## **RIVER FOREST DEVELOPMENT REVIEW BOARD MEETING AGENDA**

## MEMORANDUM

Subj: Planned Development Application – Senior Care Community (Chicago and Harlem)

**Table 6 Maximum Day Demand Plus Fire Hydraulics at Site with 4-inch Service Line**

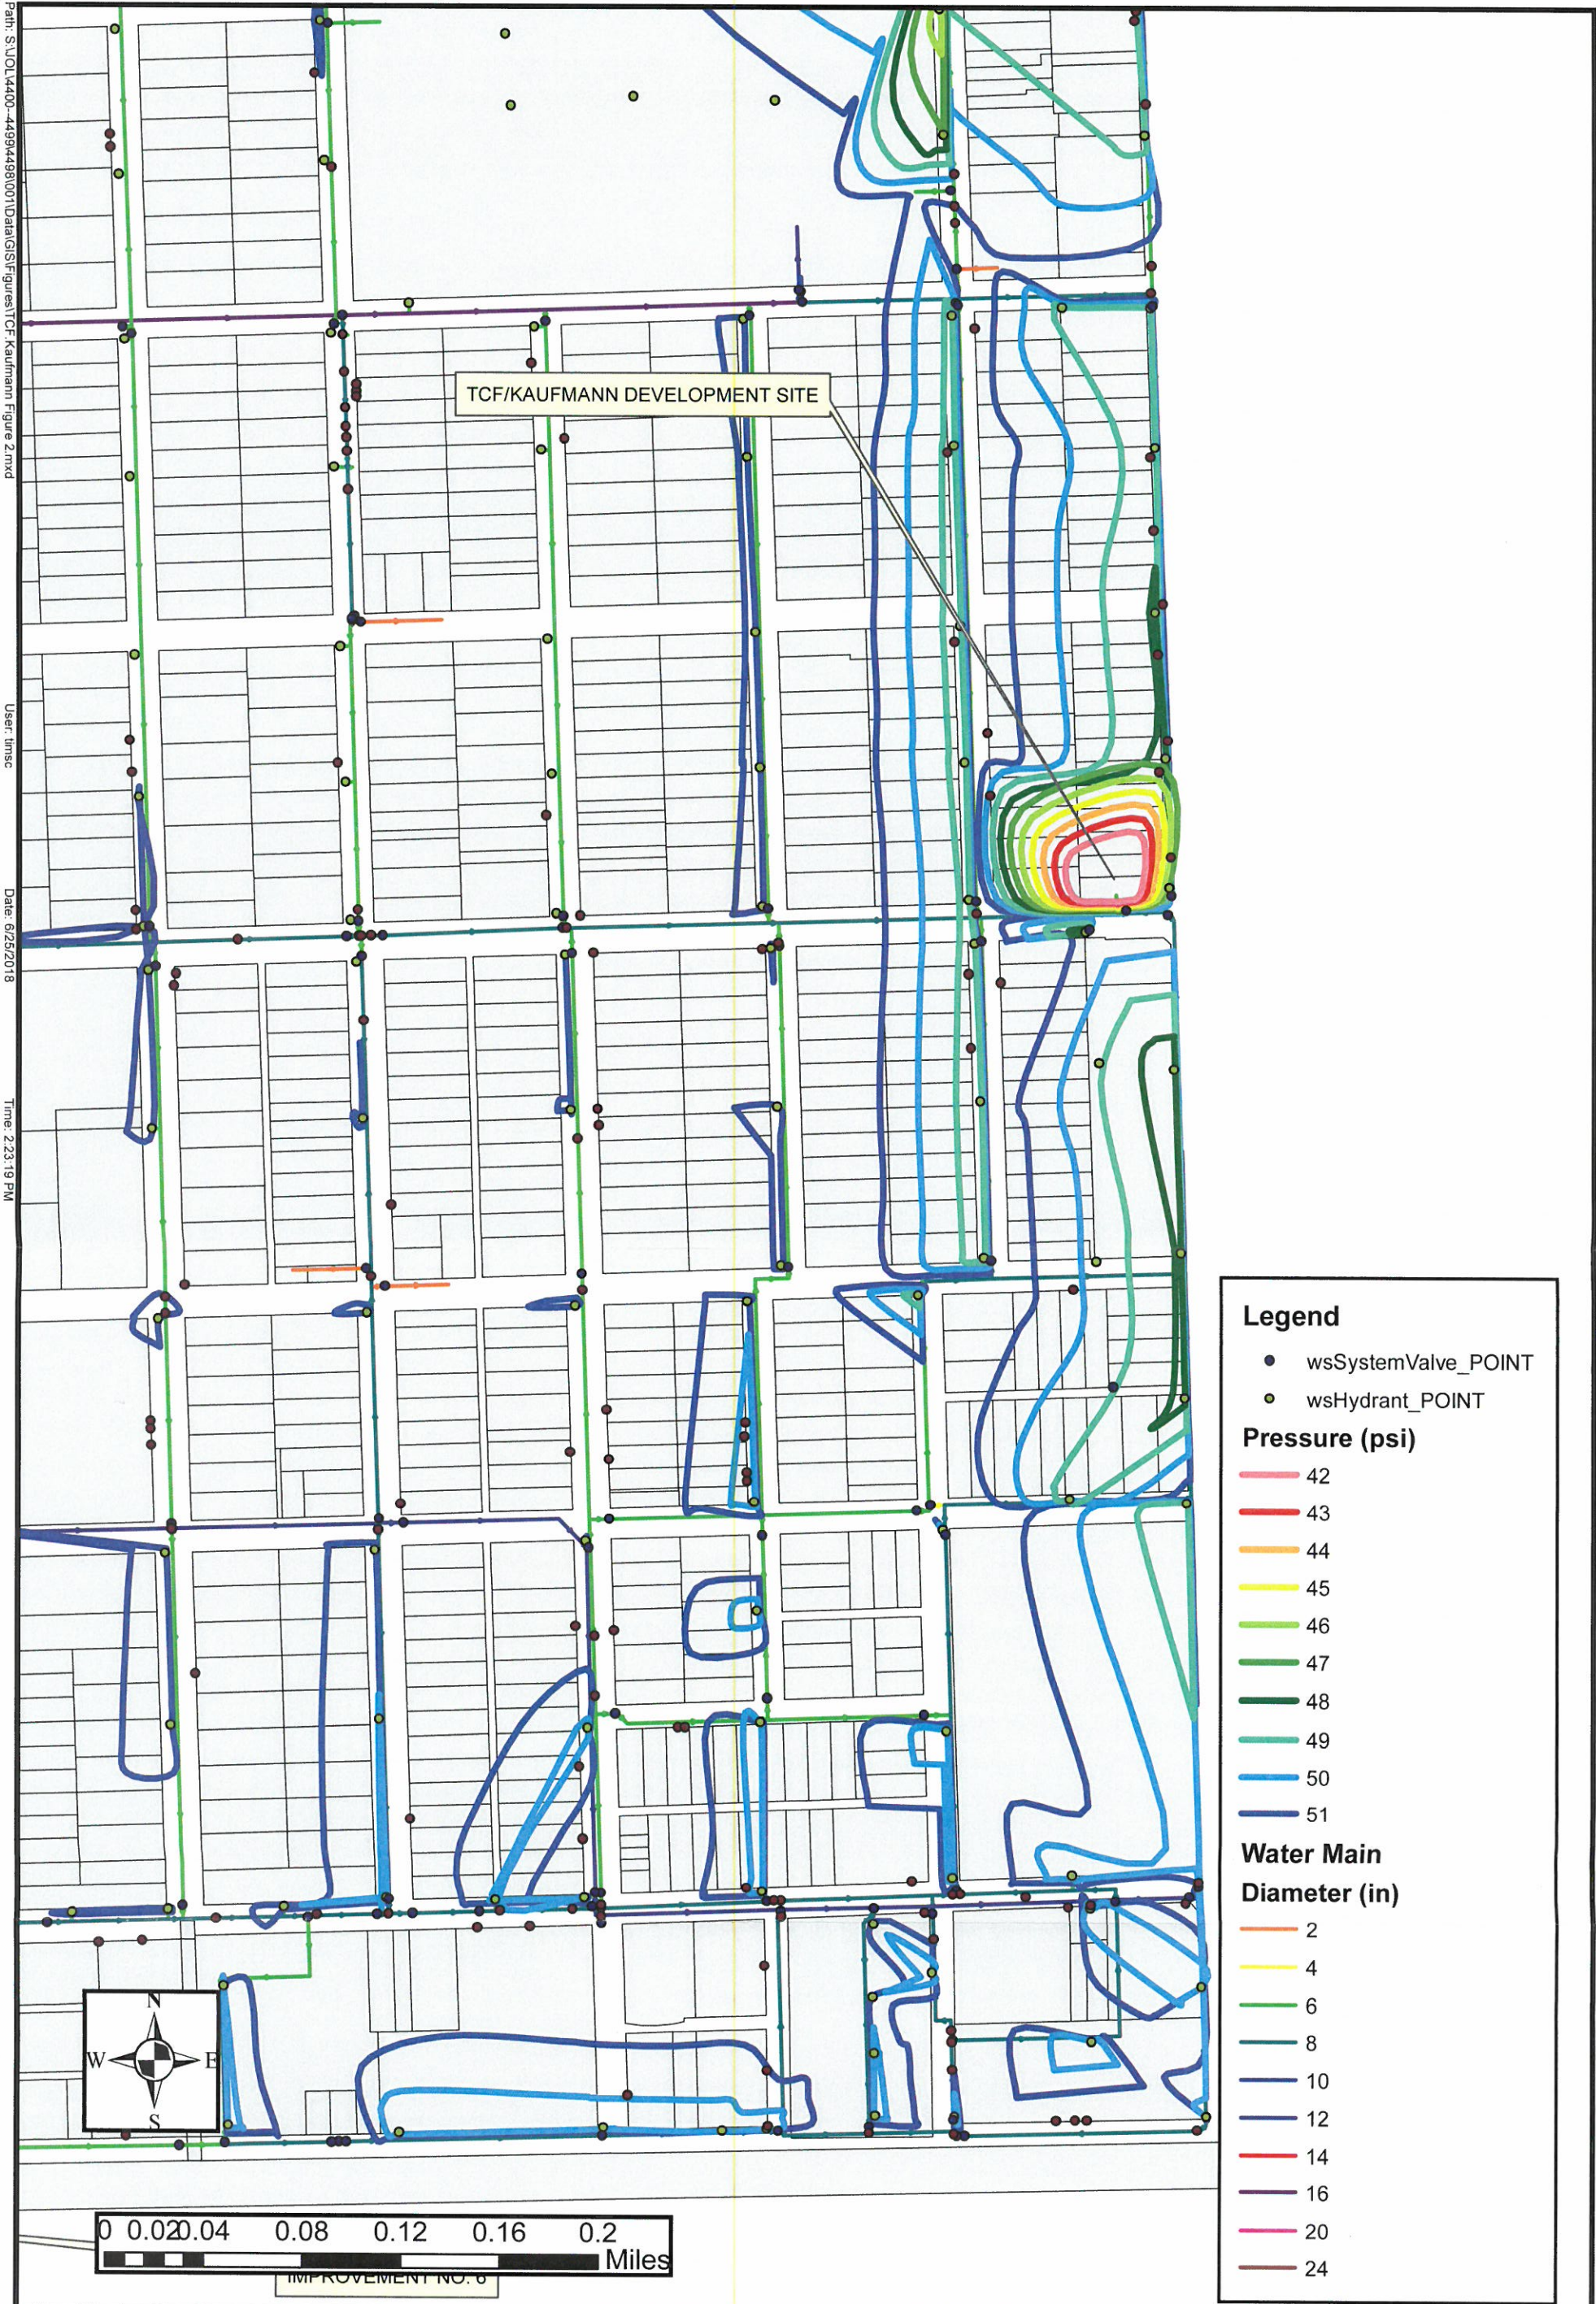
Since the sprinkler hydraulic requirements as specified by a fire protection engineer are not available at the time of this writing, we cannot definitively confirm the building can meet a desired flow rate. However, the flow rates shown in Table 6 show rates and residual pressures at the structure that precipitously decline as flow demand increases. This appears to be primarily because of head loss within the 4-inch water service line. Also, of concern with the 4-inch service line are the elevated flow line velocities at the high demand rates. Buried pipes are considered to have a high boundary flow velocity of 6 ft/sec under standard conditions and emergency flow velocities below 20 ft/sec are desired. These upper flow velocity limits are desired in order to decrease head loss through pipes and to limit the potential for water hammer. Flow velocities in the distribution system itself reached a local maxima of 5.62 ft/sec under the 1,540 gpm demand, which are considered acceptable.

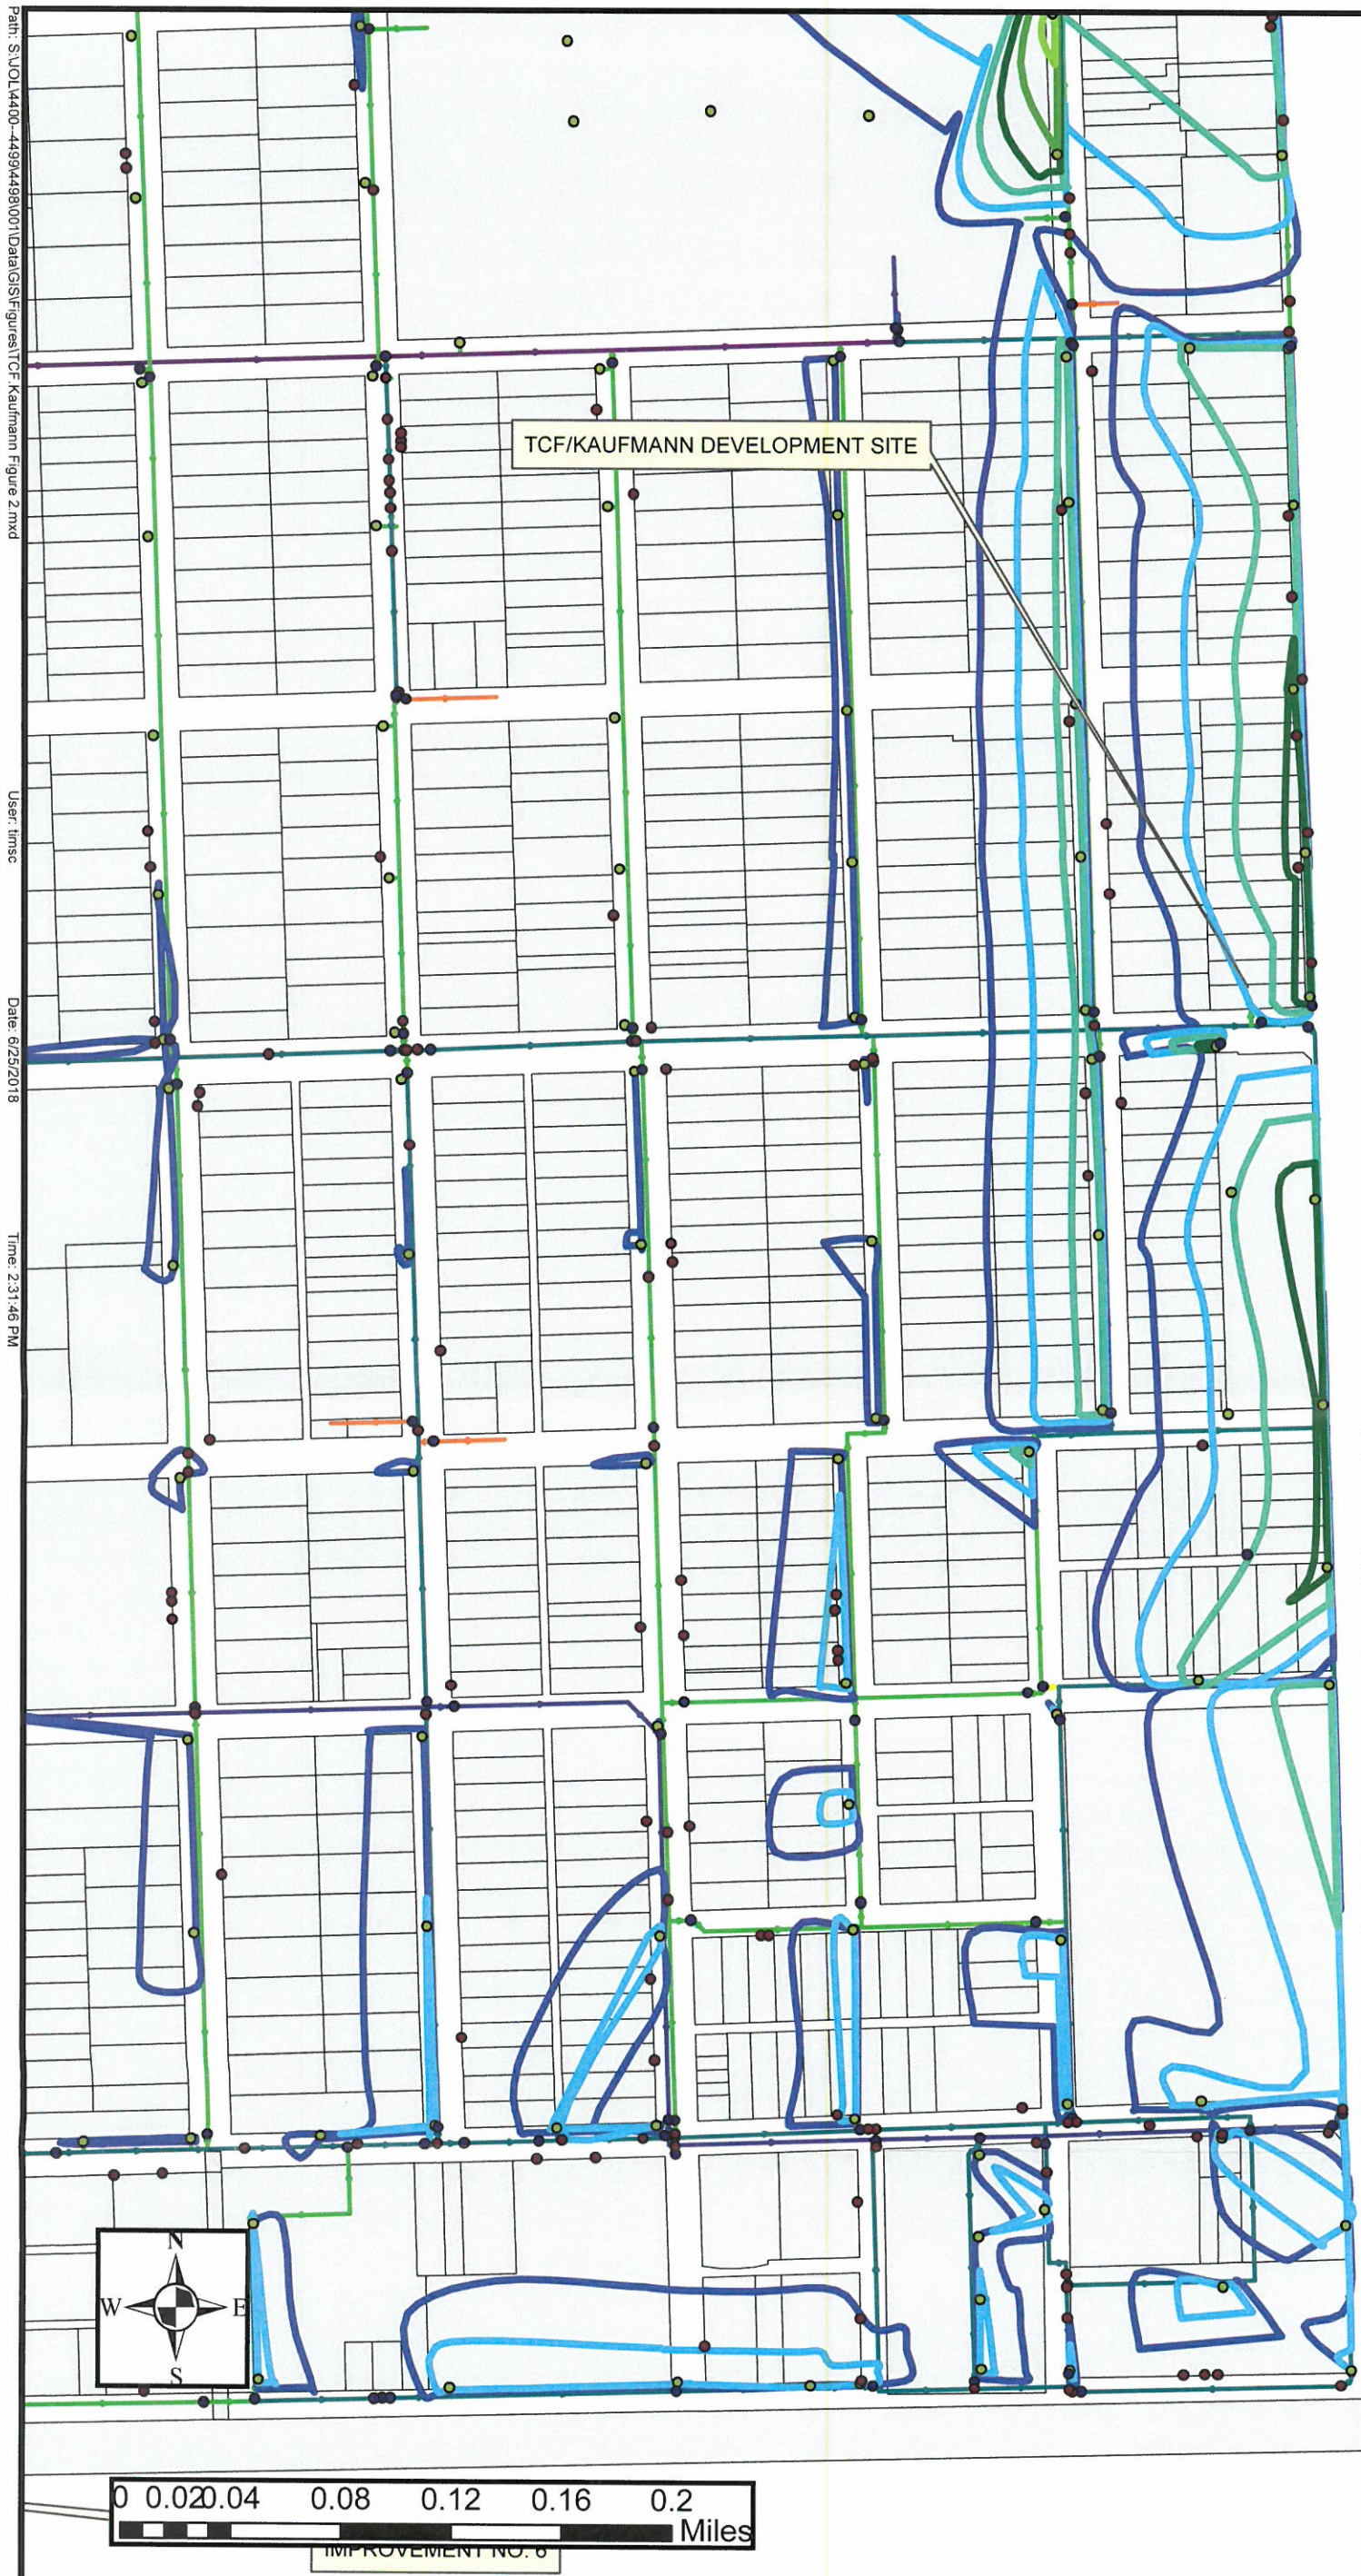
A fire flow simulation provides an instantaneous snapshot of the amount of water available at points within the distribution system while still maintaining a minimum 20 psi residual pressure at all points within the distribution system. The 20-psi minimum threshold is selected according to the Illinois Administrative Code Title 77 Part 900.40 and the Recommended Standard for Water Works (Ten States Standards). This is the lower boundary beyond which a municipality is legally required to issue a boil-order advisory. The model simulates a separate fire event at each hydrant in the system and increases the flow at that hydrant until either the hydrant itself or a point in the distribution system reaches the 20-psi residual pressure threshold. The flow at the hydrant at the 20-psi limit is defined as the  $Q_{20}$  Available Fire Flow (AFF).

Very high AFFs (over 4,000 gpm) are not considered realistic in terms of flow output from a single individual hydrant, flows physically capable at an individual hydrant will be limited by the diameter of the hydrant outlet, physical access to the hydrant, and the firefighting equipment used. High AFFs are indicative of very strong hydraulic connectivity, which could support numerous simultaneous use of numerous hydrants by a fire company to achieve flows proximate to the  $Q_{20}$  AFF. It should be noted that the size of the water service line (whether 4-inch, 6-inch, or 8-inch) will not affect the  $Q_{20}$  AFF since the  $Q_{20}$  AFF is a measure of the ability of the distribution system to supply water to the area of the fire.

The facility fire protection engineer may identify the required hydraulic profile for the proposed facility sprinkler systems, and request confirmation of the ability of the system to provide a specifically identified flow at a specifically identified pressure. If requested, we can provide a follow-up letter answering specific questions.
